Attachment 1 - PLN20/0230 - 587 - 593 Church Street Richmond - Locality Plan

**YARRA PLANNING SCHEME**  
**VCAT REF: P1074/2020**  
**PLANNING APPLICATION NO: PLN20/0230**  
**PROPOSAL: THIRTEEN (13) STOREY RESIDENTIAL HOTEL**  
**ADDRESS: 587-593 CHURCH STREET RICHMOND**

TO:	Michelle King (Statutory Planning)
FROM:	Amruta Pandhe (Urban Design)
DATE:	11 August 2020
SUBJECT:	587-593 Church Street, Richmond
APPLICATION NO:	PLN20/0230
DESCRIPTION:	Use and development of the land for a thirteen storey residential hotel (with an ancillary gym and function centre), a ground floor restaurant and a roof-top bar (all permit required uses), a reduction in car parking and alteration of access to a road zone, category 1

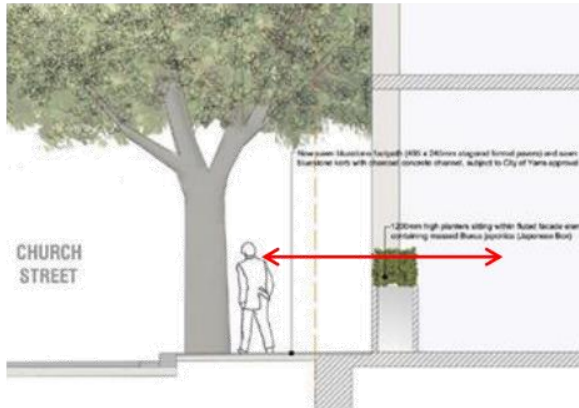
The development proposes raised planters along Church Street and Yorkshire frontage. The provision of planters is supported, however, the 1200mm high planters will obstruct visual connection between public realm and private spaces. Hence it is recommended to reduce the height of the planters as much as possible without impacting the landscaping requirements (full growth potential of the planters). This will contribute in making the street interface more engaging and safe. Refer to Open Space team comments for further details.

Ensure visual connection between public realm and private spaces

### *Landscape Sections – Lower Levels (Landscape Drawings)*

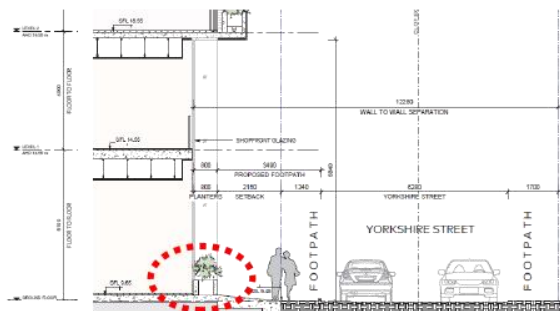
Please update the elevations, sections and renders in architectural drawings to incorporate right information about planters. Below section from UCR shows low level planters which is used to demonstrate ground floor activation which is not the case as per landscape drawings. Perspective 3 shows only few planters (probably 1200mm height) and perspective 4 shows all planters but at lower height. There also seems to be discrepancy in upper level landscaping.

Suggested layout showing tree locations along Yorkshire Street

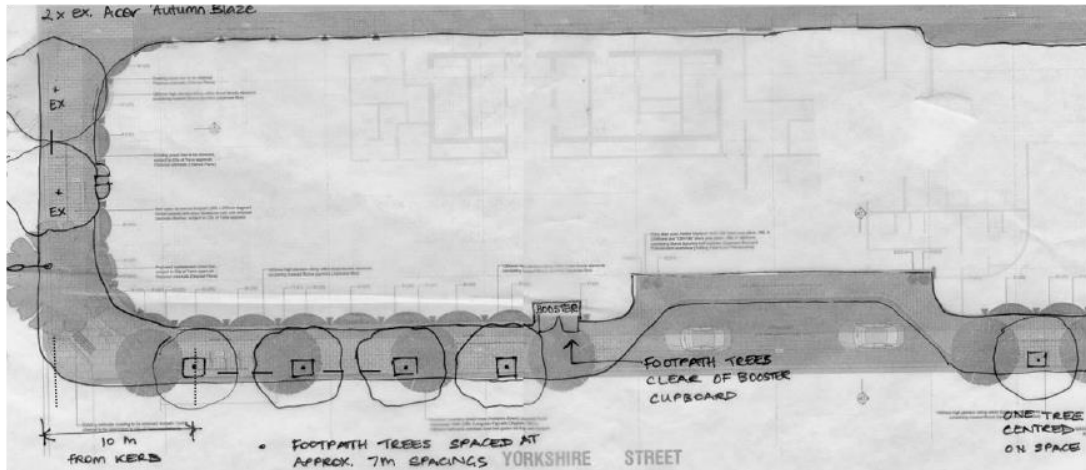
Below are further details and a sketch layout showing the potential location of trees along Yorkshire Street which provides slightly more sight line visibility at the Church Street corner and clearance in front of the Booster access.

- The approximate cost for footpath tree is \$565 per tree
- Distance between trees is approximately 7m from centre to centre
- Council does not support provision of tree grates in this location for maintenance and street character reasons. The trees will be planted in standard 1m X 1m tree cut out which will also enable them to be located on Council land and therefore be maintained by Council

- Pleached *Ficus macrocarpa* 'Hillii' are not supported as they require high maintenance. Council will either plant '*Magnolia grandiflora* 'Greenback' or *Tristaniaopsis laurina* 'Luscious'. The decision will be made by Council's arborist at time of implementation.

Ground Floor Plan (Architectural Drawings)

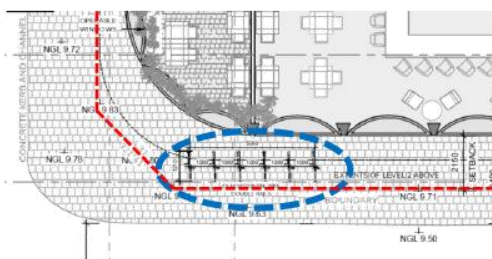
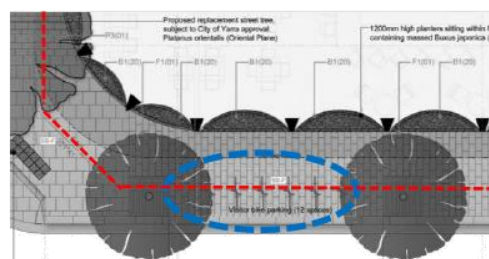
Church Street is an active thoroughfare which is becoming increasingly busy during daytime and evenings. Hence it is important to provide public infrastructure such as bicycle parking for the community. The development proposes six bike hoops along Yorkshire Street. The provision of bike hoops is supported, however, it is recommended to have one bicycle hoop along Church Street and four along Yorkshire Street.

The bike hoop along Church Street should be parallel with the kerb. The proposed bike hoops along Yorkshire Street are perpendicular to the kerb which does not allow to maintain a 1.5m-1.8m clear path of travel for pedestrians. Hence, the bike hoops along Yorkshire Street should also be parallel to the kerb. Ideally it is preferred that bike hoops provided to meet planning application requirements to be within private boundary. However, in this instance it is preferred to have the bike hoops on Council land between the proposed trees to maintain a clear path of travel for pedestrians.

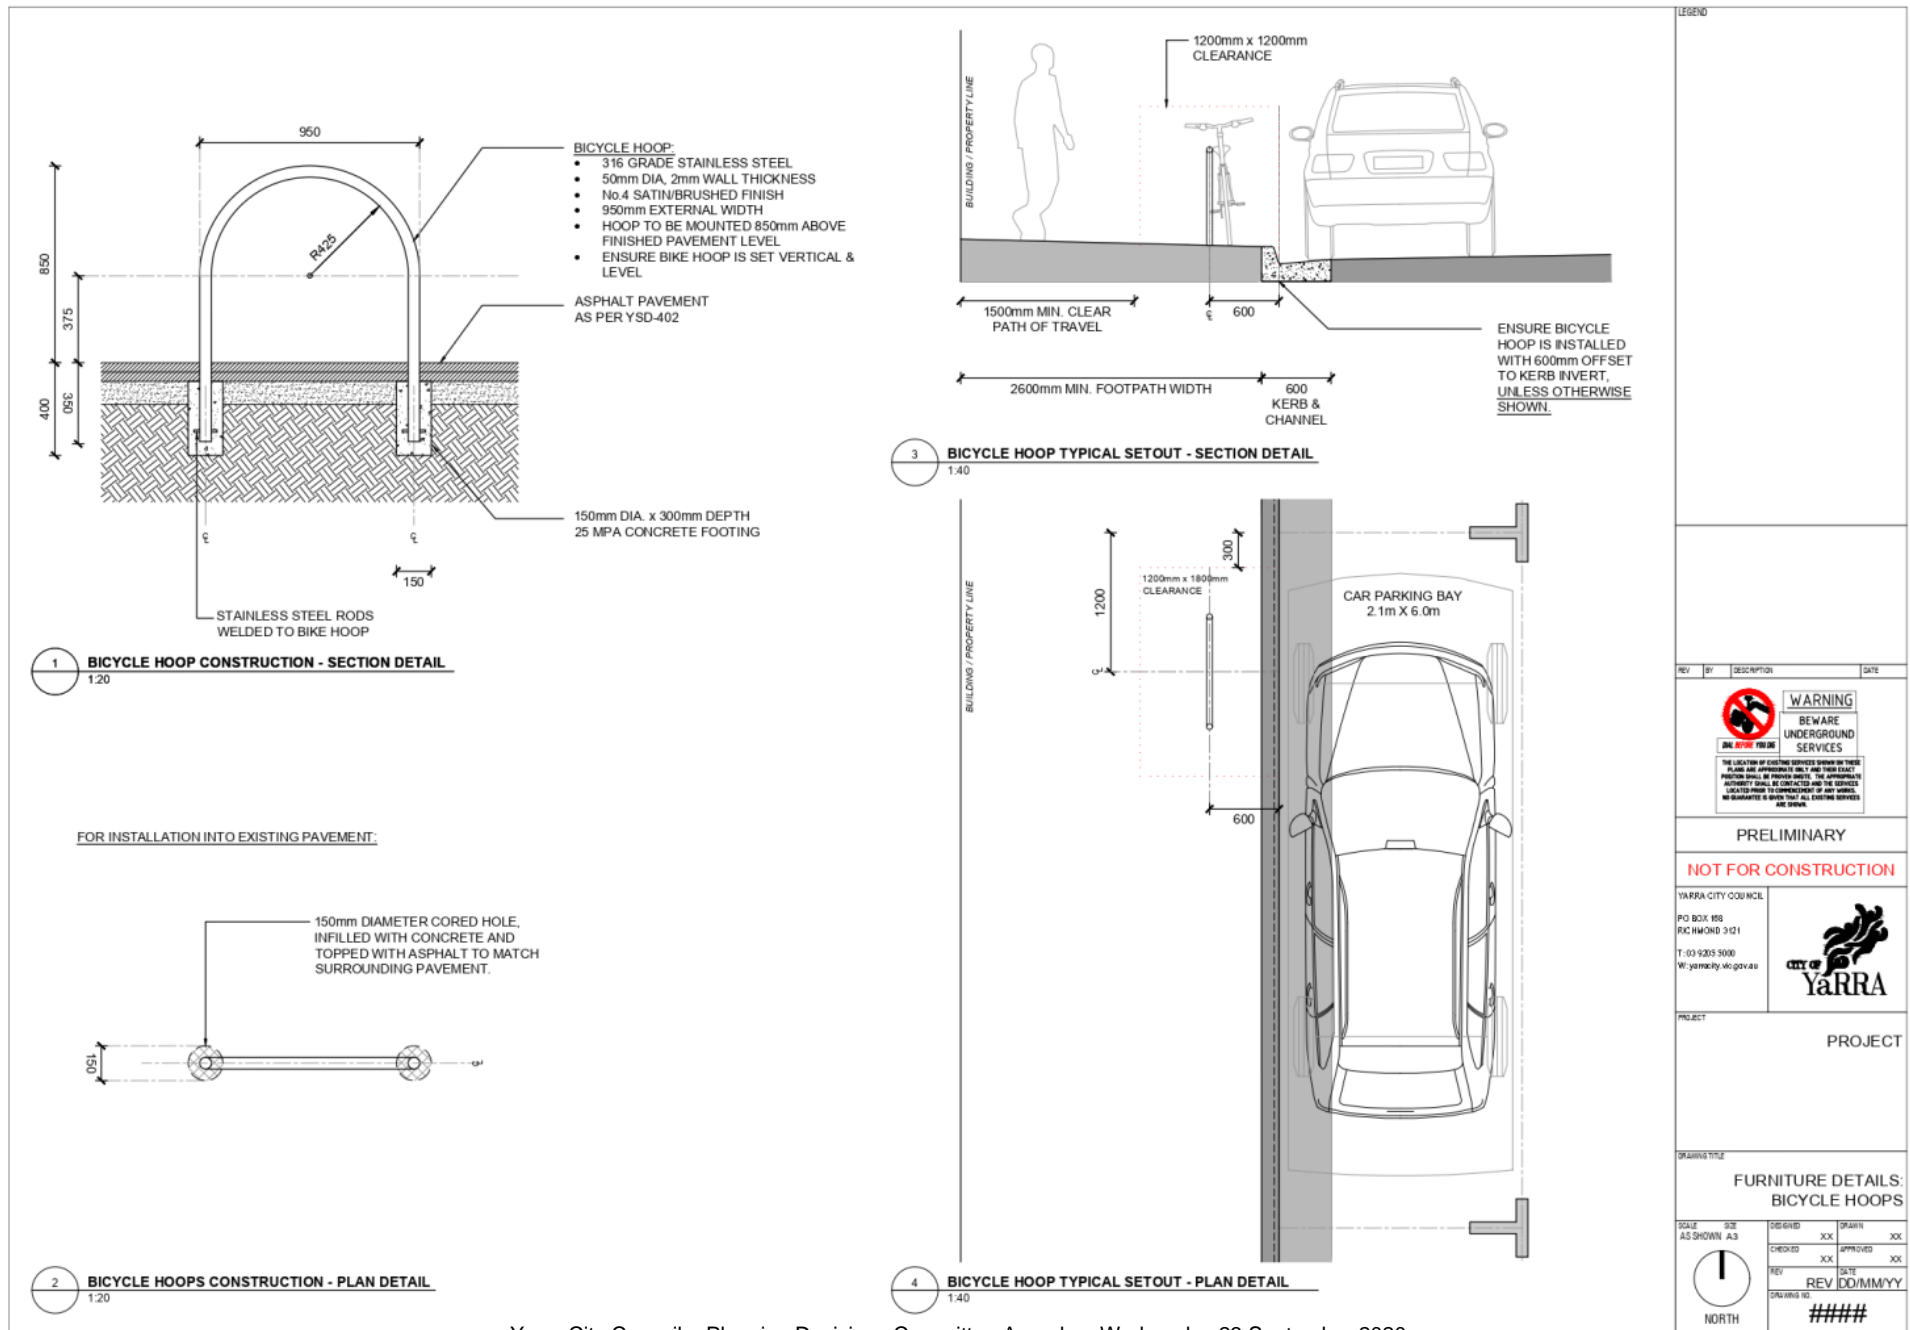
The pedestrian kerb crossing at the intersection of Church Street and Yorkshire Street should align with the direction of travel required to cross the south side of the street only. Hence, it is recommended to provide a straight crossing at this corner which will be similar to the existing crossing on south of this intersection. The provision of tactiles is not supported. Consideration to drainage pit and any other existing infrastructure should be given while designing the crossing.

Proposed crossing to be shown on drawings and reinstated as per *Yarra Standard Drawings (YSD404 – Kerb layback pram crossing)*.

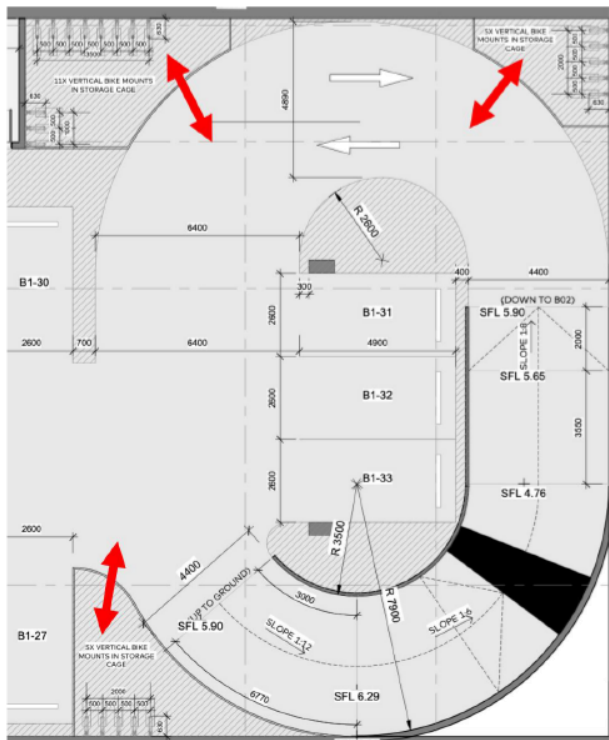
- Additionally, a number of the bicycle spaces are located adjacent to vehicle ramps with blind corners (shown in Figure 1 below); this access arrangement is not considered safe.

- All employee / resident bicycle spaces and access ways should be positioned in accordance with the clearance requirements of AS2890.3.
- Six shower / change rooms are provided on level 2, which exceeds Council's best practice standards.
